Re: In the Matter of Commonwealth Edison Company
(Byron Nuclear Power Station, Units 1 and 2)
Docket Nos. 50-454 and 50-455 -OC

Please find enclosed for your review a letter dated December 30, 1983 from Mr. Cordell Reed to Mr. R.C. De Young with the attached "Byron IDI [Integrated Design Inspection] Response."

Attachment A
Byron IDI Report Response

FIGURE 1

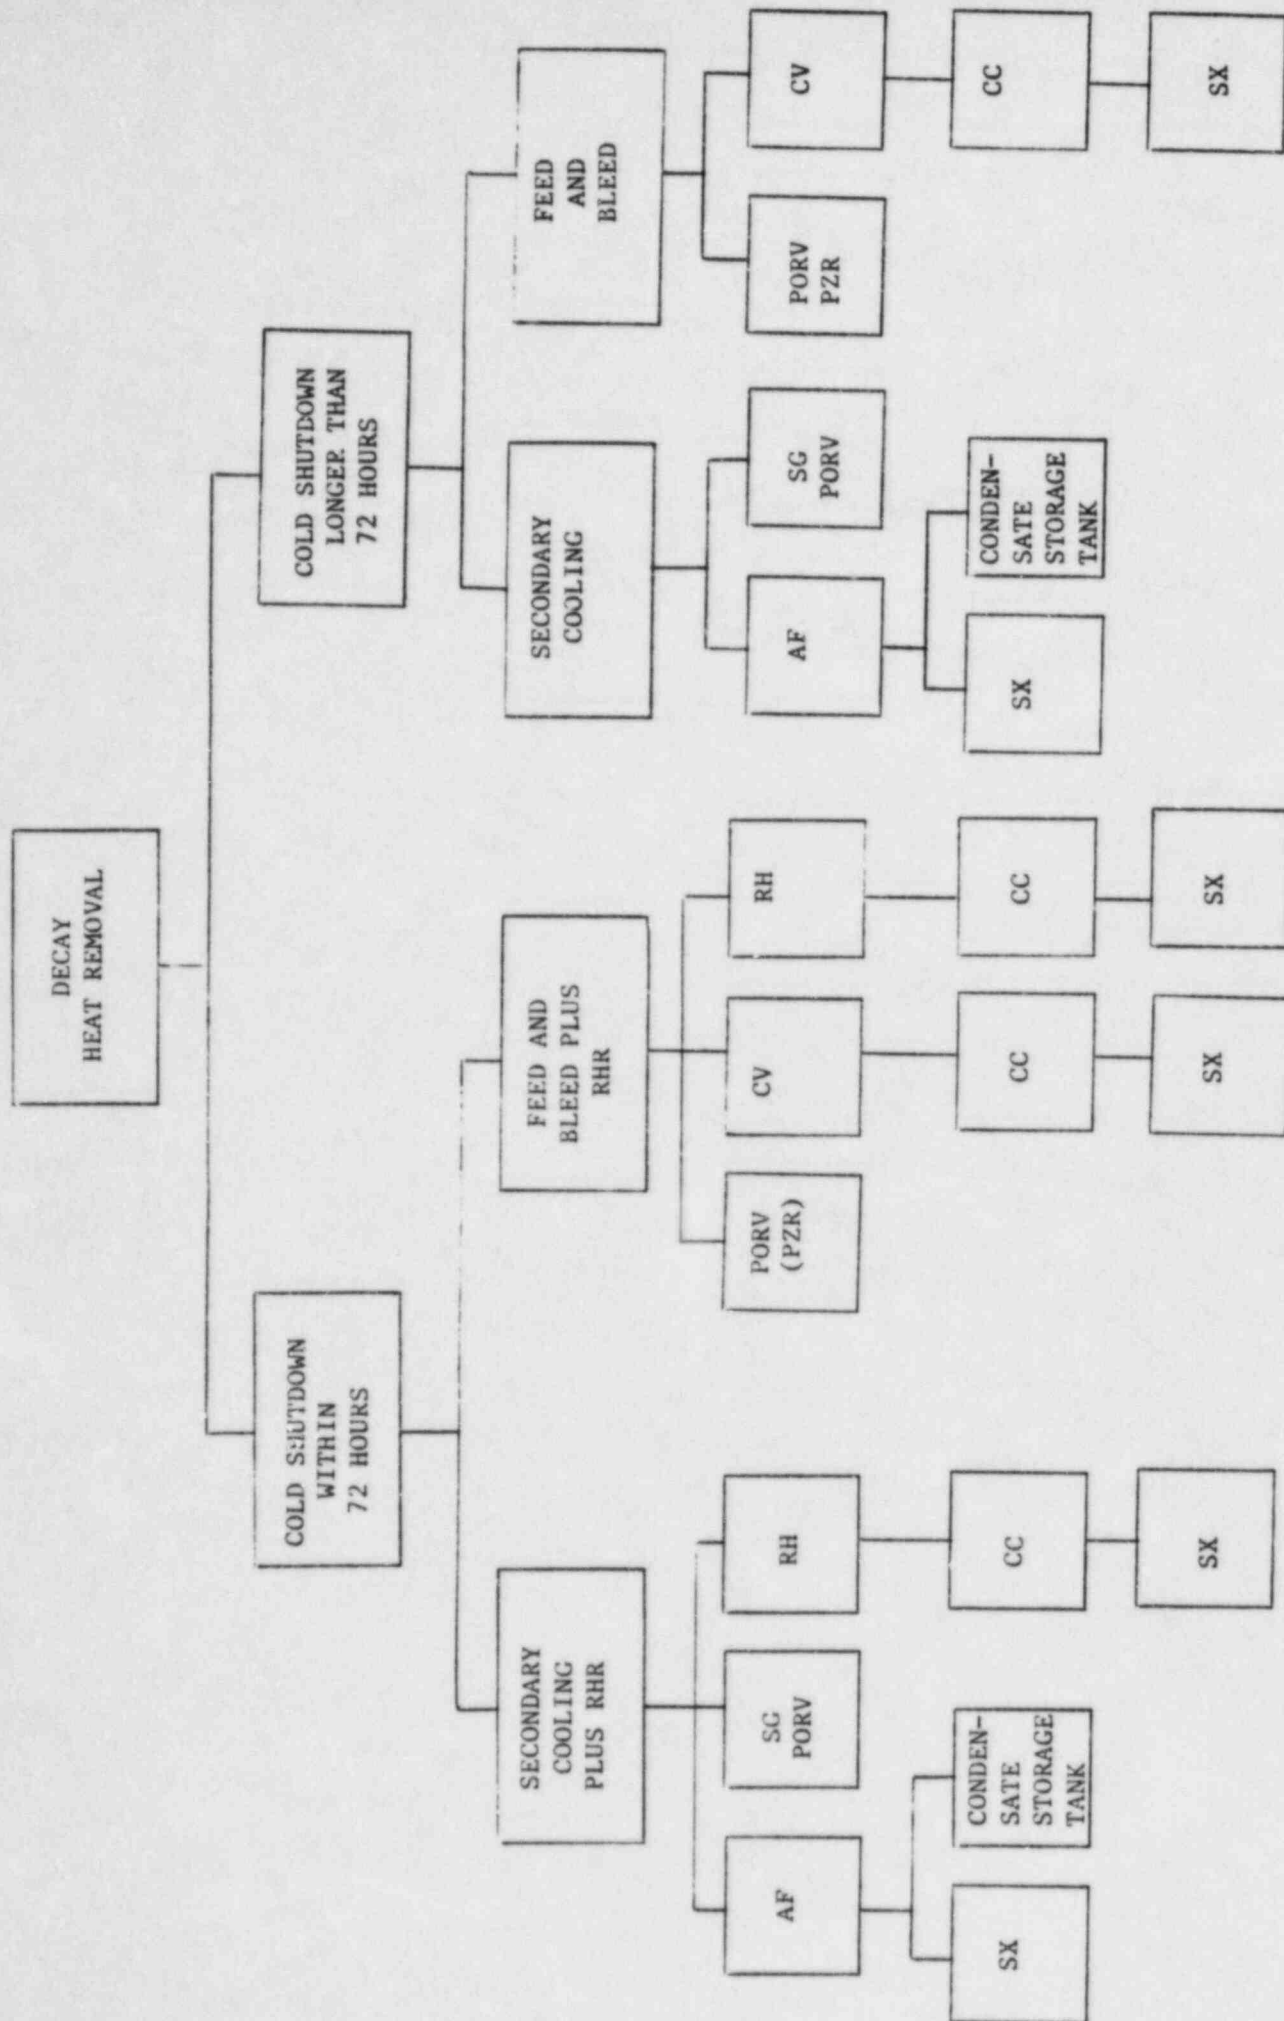
The function and redundancy of these systems can best be seen by examining a diagram of the various paths for safe shutdown decay heat removal as shown in Figure 1. This diagram shows four paths. Two of these reach cold shutdown within 72 hours while the other two (without RHR) may taken longer than 72 hours. These paths assume offsite power has been lost.

As shown in Figure 1, the RH system is required only to reach cold shutdown in a short time. The only RH component outside containment which could be affected by spray is the RHR pump motor. This motor is located in a room adjacent to the containment which contains only one train of the RH system. As a result, any crack which causes failure of one RHR train will not require postulation of a single failure in the redundant train.
